A095004

Response to Comments Receive on 27th October 2017 from Carol Reynolds, Environmental Health for Arun District Council regarding planning application LU/278/17/RES – Discharge of Condition 36

Project:
Lyminster Bypass,
North Littlehampton

Drawing Title / Scenario:
Receptor and Acoustic
Barrier Locations

Drawing Number:
SK02

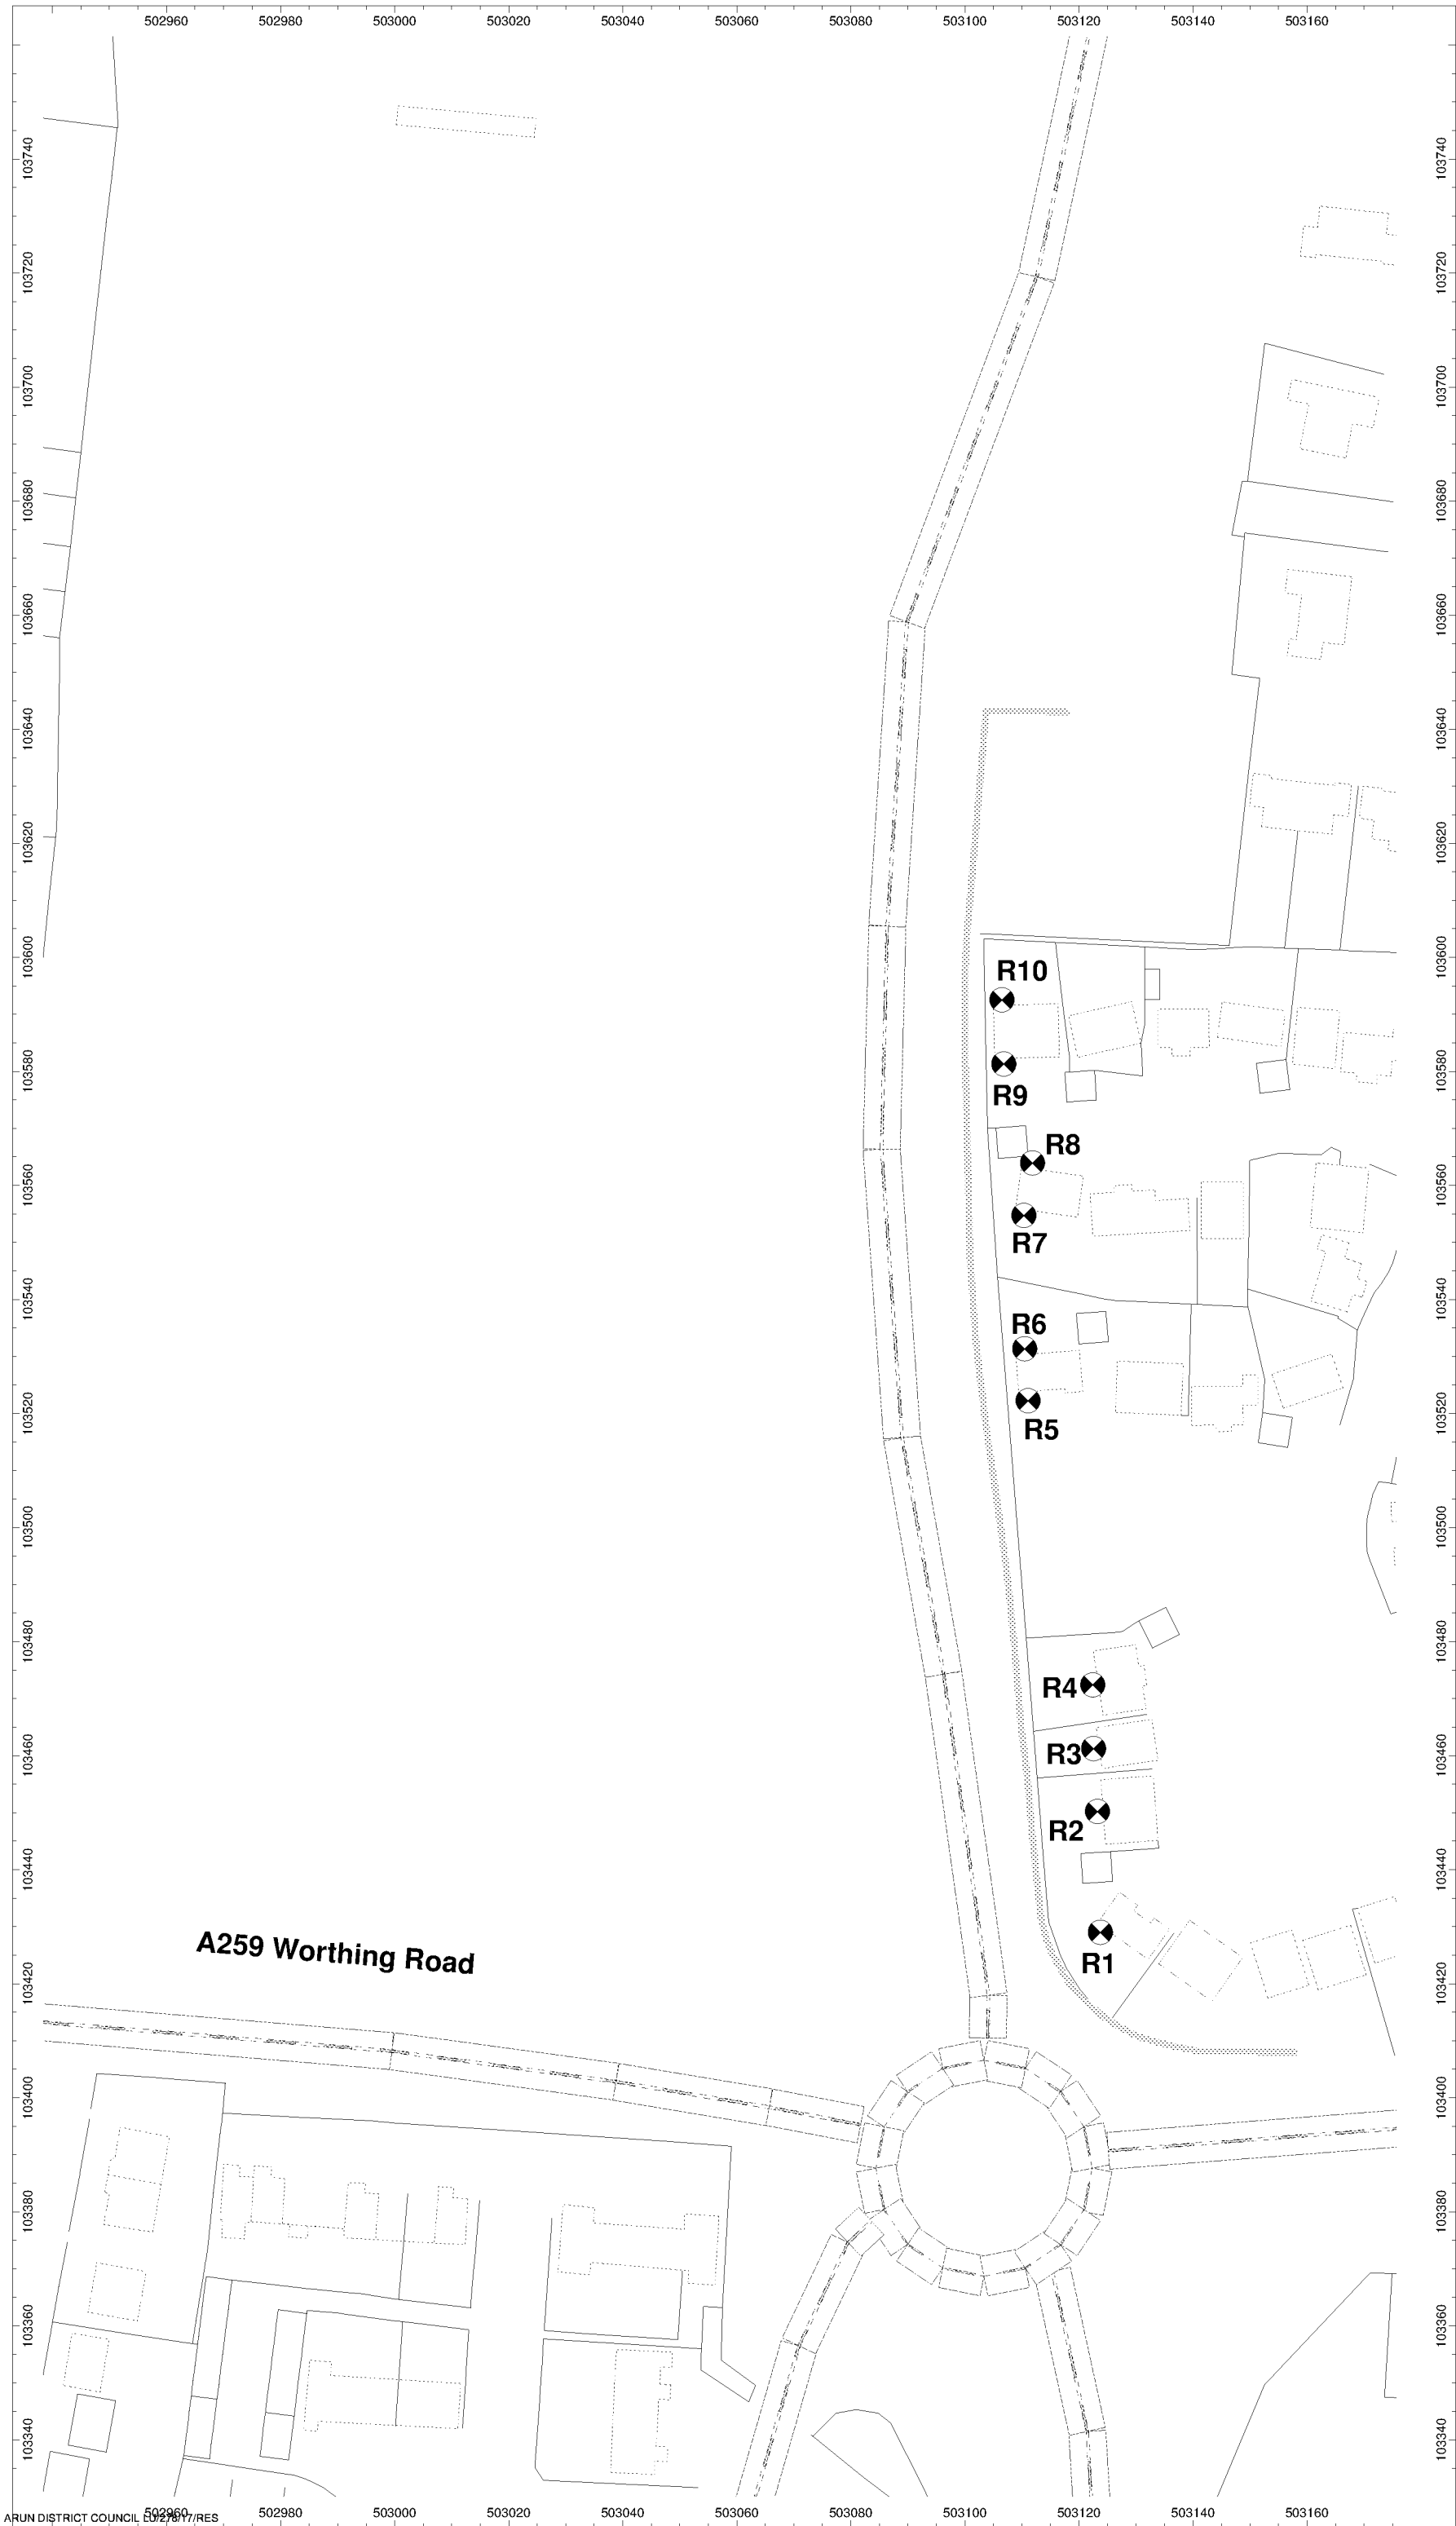
The Environmental Statement, Volume 1, February 2011, p 275, paragraph 10.6.2, 'Operational Noise' highlighted that properties bordering the east of the proposed Lyminster Bypass at Toddington Park were considered likely to require noise mitigation during the operational phase of this new road, namely a 2m minimum height acoustic timber barrier. That Noise Assessment prepared by WYG, August 2017 in respect of discharge of the above Condition proposes a 3m high acoustic barrier to extend around properties referred to as R1-R7 on Drawing Number SK02 and somewhat to the north of this; of given construction (Appendix C) which, it is stated, will achieve noise attenuation of up to 7.4dB (p18). Whereas this approximates to the location of Number 9 to 23 Toddington Park, please provide clarification as to which dwellings these references pertain.

The dwellings that will receive the 7.4dB reduction in noise levels as a result of the 3.0m barrier as stated in the report are TR6 which is representative of 14 Toddington Park and TR10 which is representative of 23 Toddington Park. Attached to this response is an updated version of SK02 showing these receptor locations.
